Application number: DA2021/0303
5 Carrington street PALMERS ISLAND NSW 24634

Objection to Development Application DA2021/0303

Proposed Development Dwelling at 5 Carrington St. Palmers Island

Re: DA2021/0303 - 5 Carrington St Palmer Island

Figure 1: Site Plan, 5 Carrington Street Palmers Island.

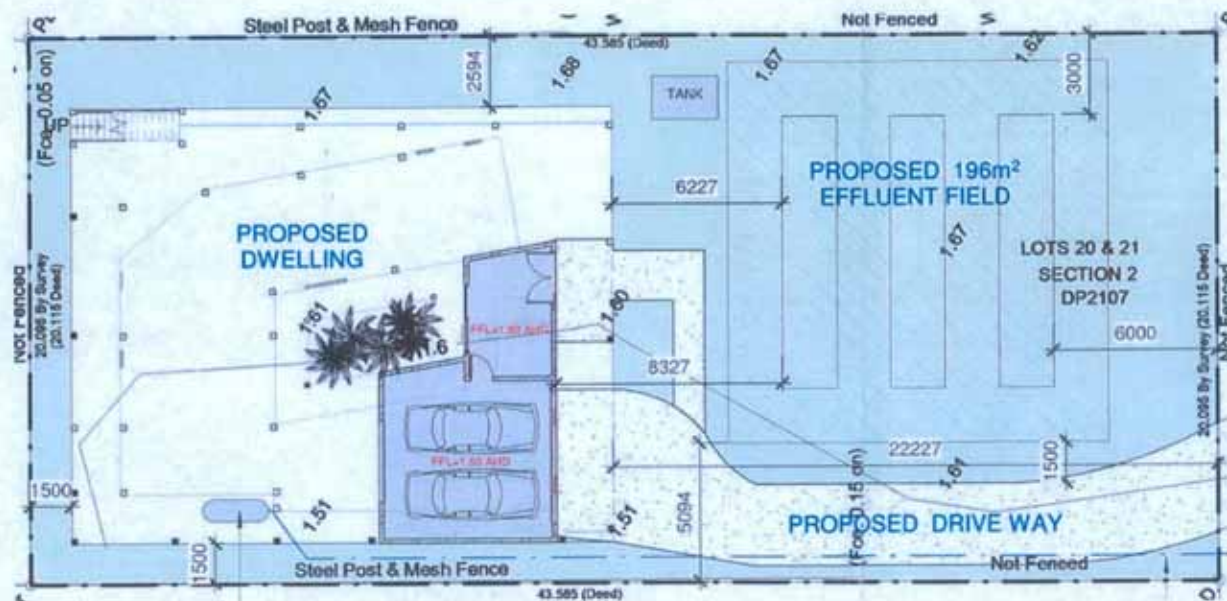
The Site Plan details a Tank, assumed to be a secondary treatment system, discharging to three Evapo-Transpiration Beds totalling 60m² and located within a nominated Effluent Field of 196m² (see Figure 1).

A soil test pit was excavated 10 metres to the south of the nominated Effluent Field, (see Figure 2 & 3). The test pit identified sandy loam topsoil, overlying 600mm of loamy light clay, and grey sand from 900mm. Standing water was encountered at 950mm (see Figure 4). As the Standing Water Level (SWL) is less than one metre deep, effluent application poses a high risk to ground water.

The proposed Evapo-Transpiration Beds will require excavation to 450mm depth. This method of application will result in separation of only 450mm from the beds to ground water. Therefore, Evapo-Transpiration Beds are not favourable.

The design nominates a two metre area around the Evapo-Transpiration Beds as the Effluent Field. This is likely to address the Nutrient Balance area provide suitable area for nutrient uptake. Within loamy clays the main force is drainage rather than lateral movement. As SWL is only 450mm below Evapo-Transpiration Beds the Nutrient Area is redundant and completely ineffective.

AS/NZS 1547:2012, Table K2 states Mounds and Irrigation Systems are preferred for sites with a Shallow Permanent Water Table.

Use of a Mound System for application of effluent would be most suitable. Use of a Mound for effluent application would:

1. Provide tertiary treatment of effluent, (*Total Nitrogen reduction of greater than 60%, and Total Phosphorus reduction of greater than 80%*).
2. Lessen the risk associated with poor maintenance, poor treatment, or failure of the secondary treatment plant.
3. Increase the separation between point of effluent application and permanent ground water by more than 1metre.
4. Lessen ground water quality risk.
5. Reduce the required Land Application Area to approximately 70m².
6. Ensure all buffers to boundaries can be maintained.
